YANKEE NUCLEAR POWER STATION

AMENDMENT TO FACILITY OPERATING LICENSE

Amendment No. 69
License No. DPR-3

ATTACHMENT TO LICENSE AMENDMENT NO. 69

FIGURE 2.1-1

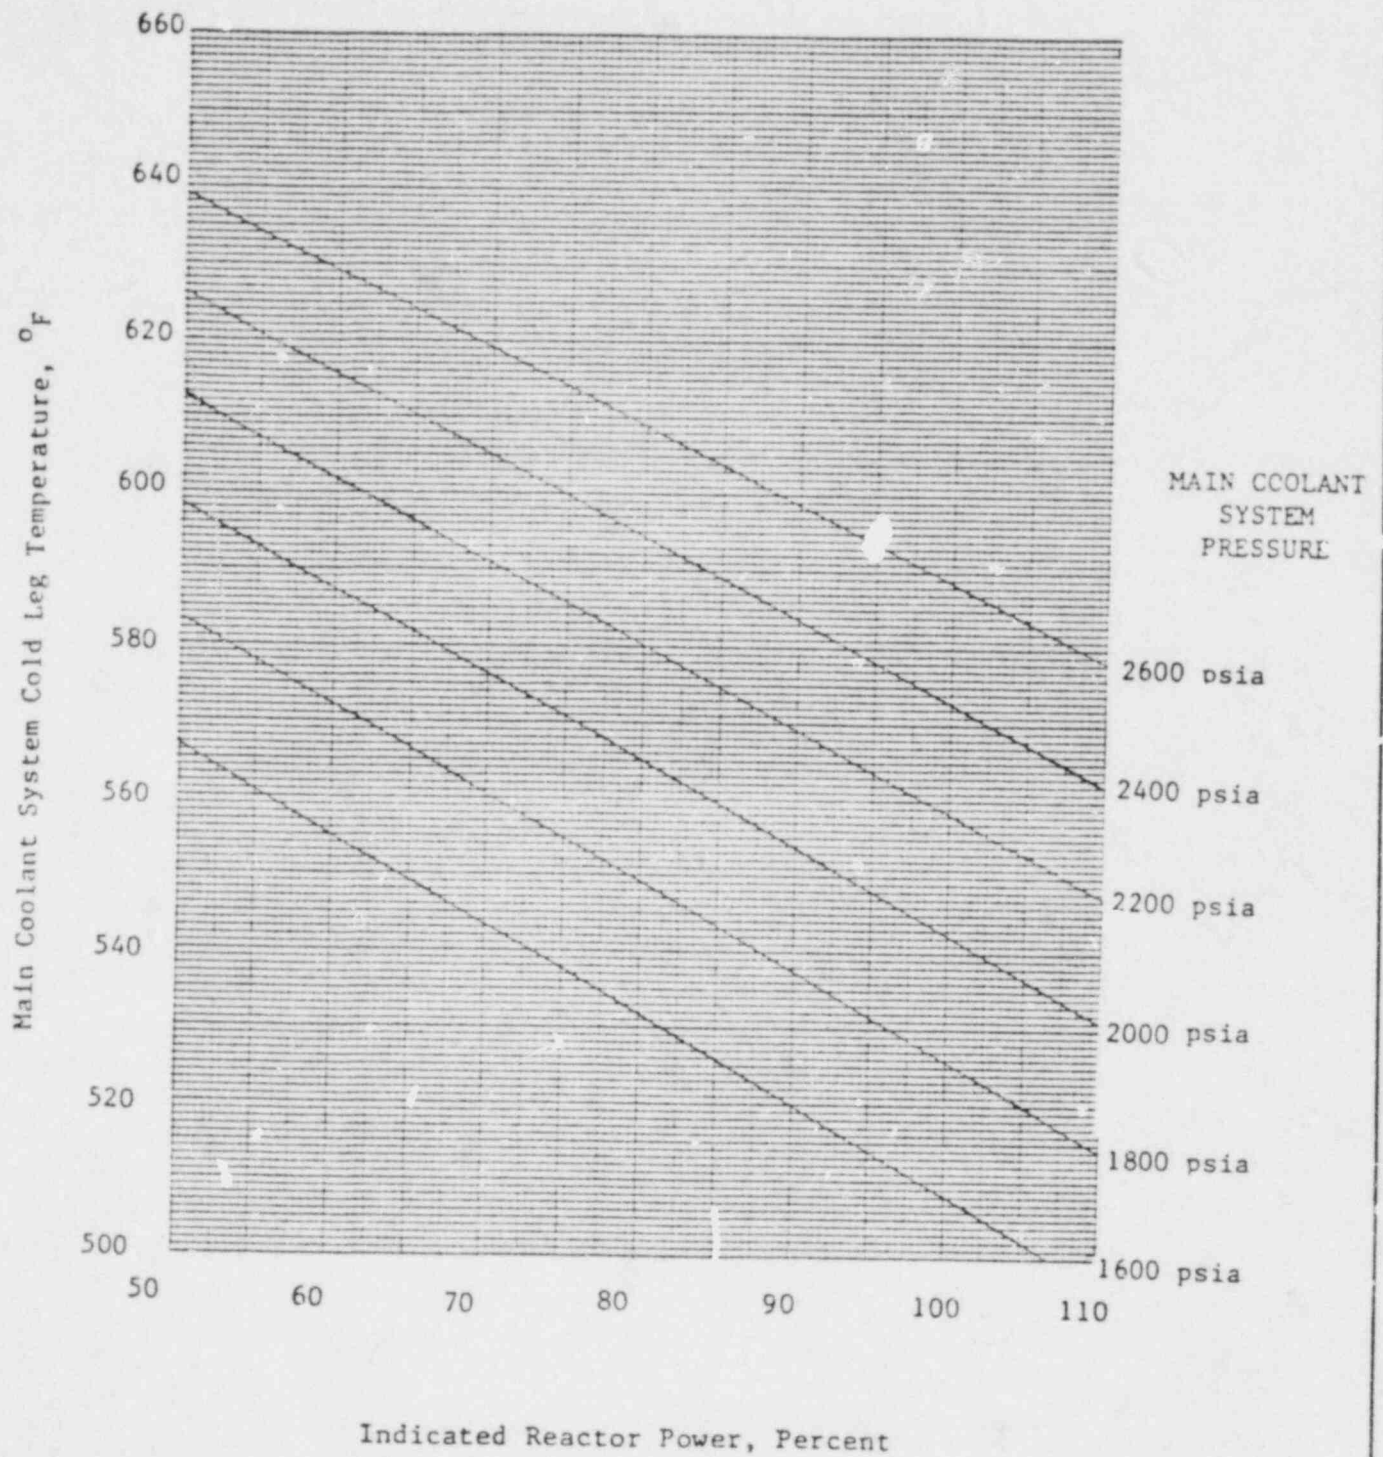
2.1.1 The combination of THERMAL POWER, Main Coolant System pressure, and the highest operating loop cold leg coolant temperature shall not exceed the limits shown in Figures 2.1-1 and 2.1-2 for 4 and 3 loop operation, respectively.

FIGURE 3.2-1

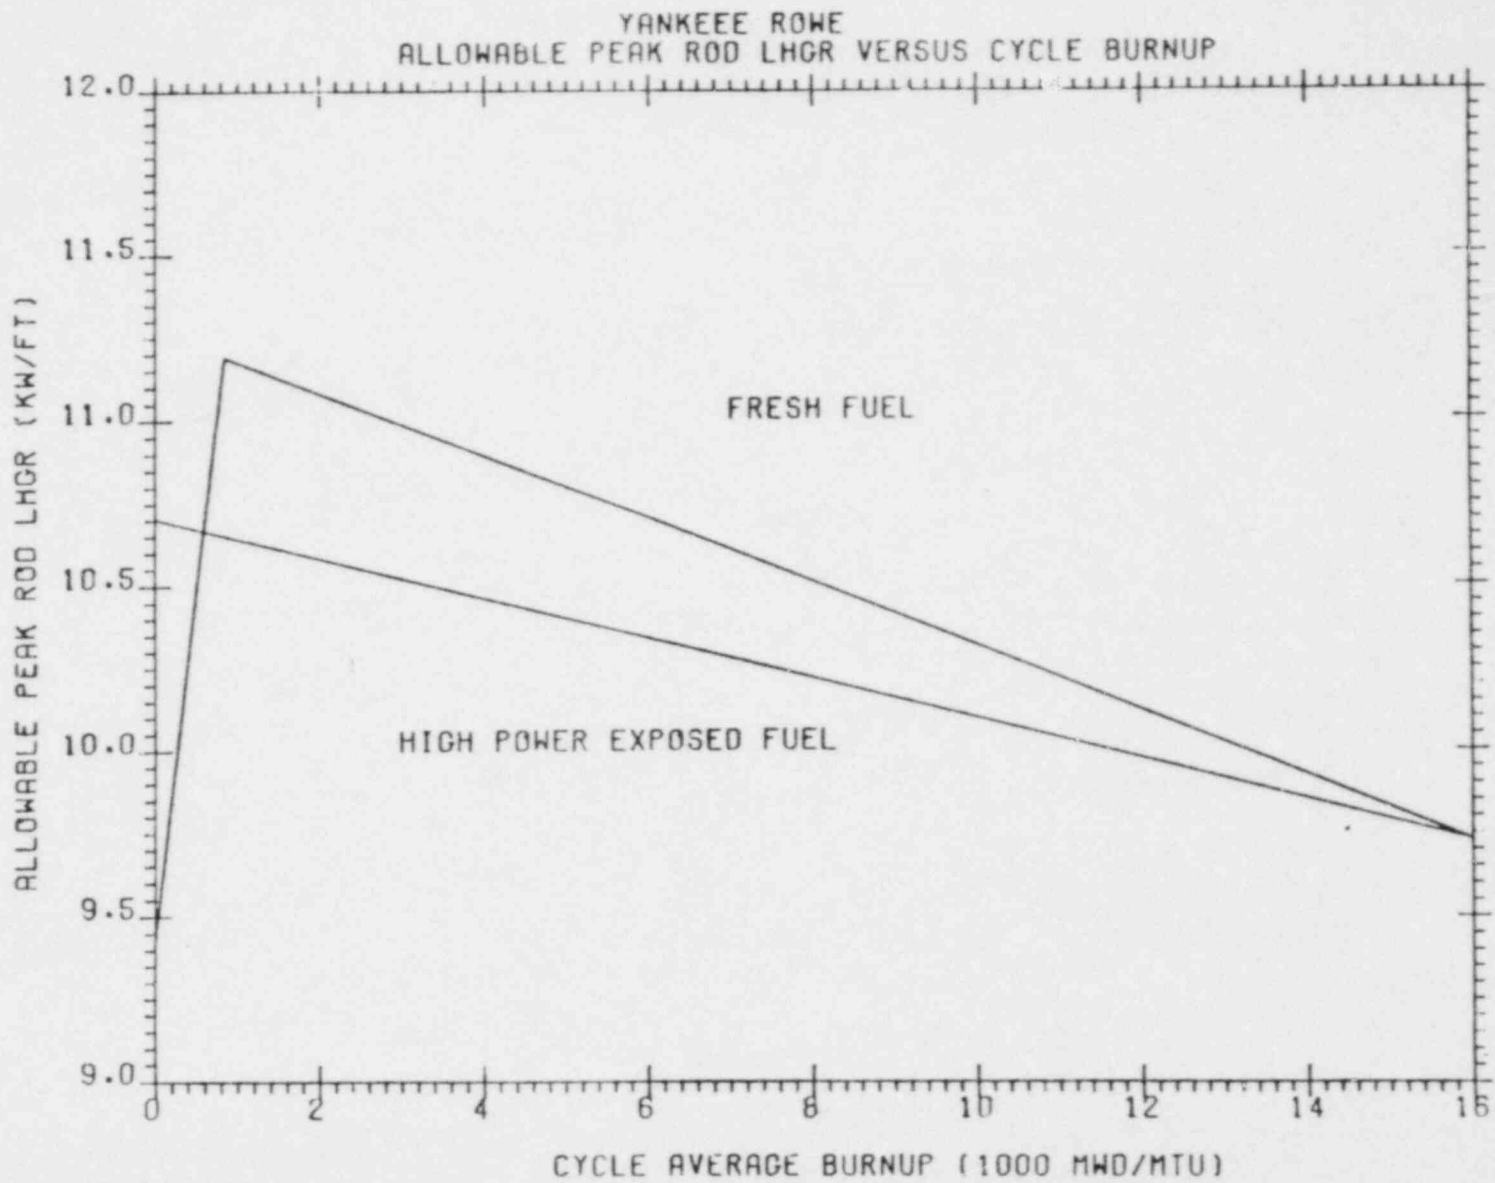
ALLOWABLE PEAK ROD LHGR
VERSUS CYCLE BURNUP

FIGURE 3.2-2

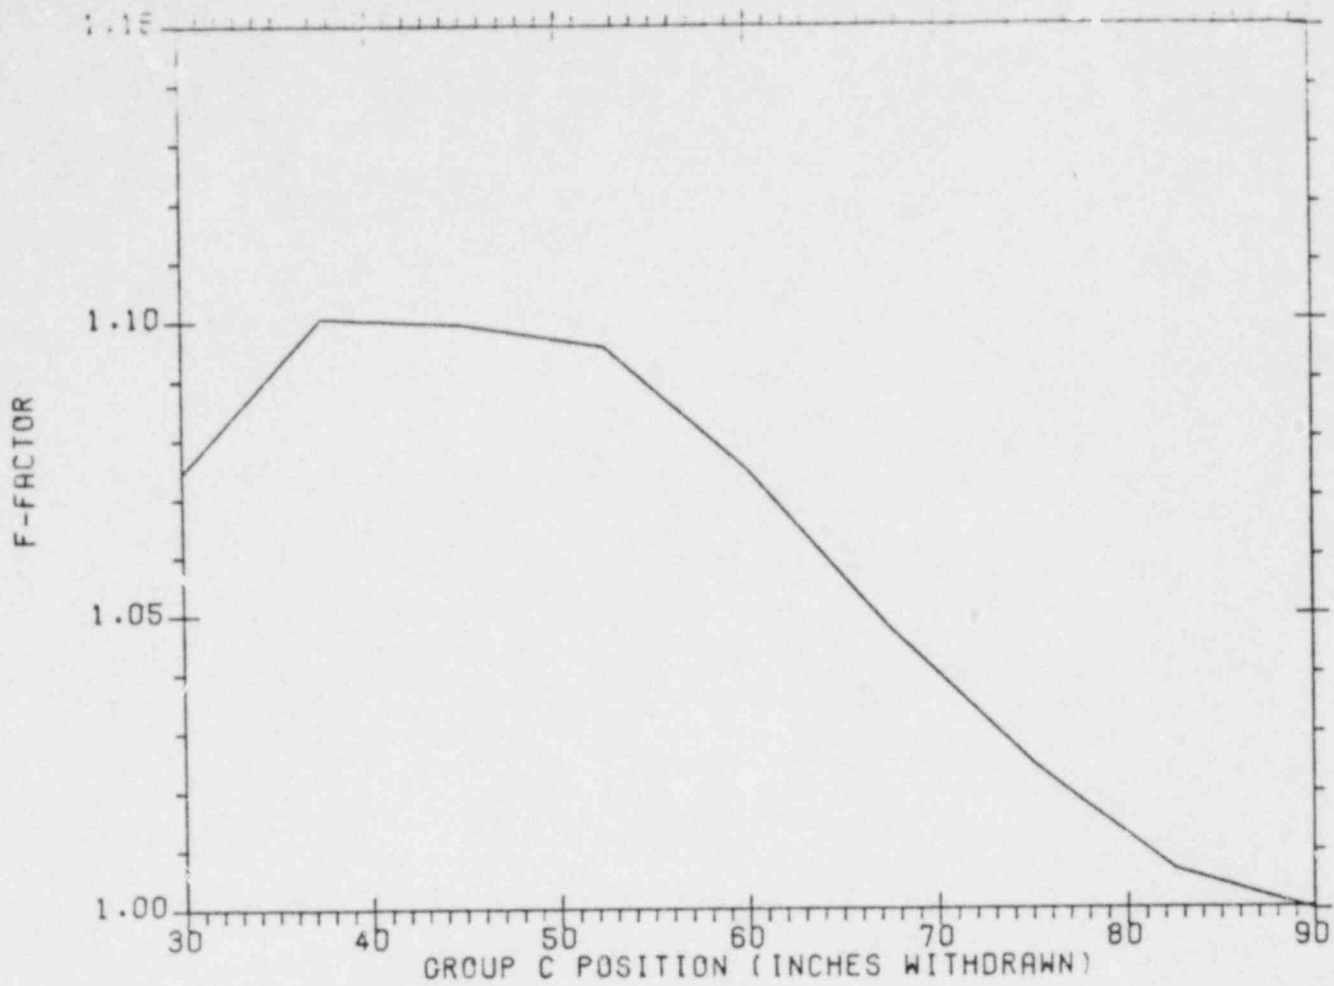
$$F_I = \frac{F @ \text{Limit}}{F @ \text{Measurement}}$$
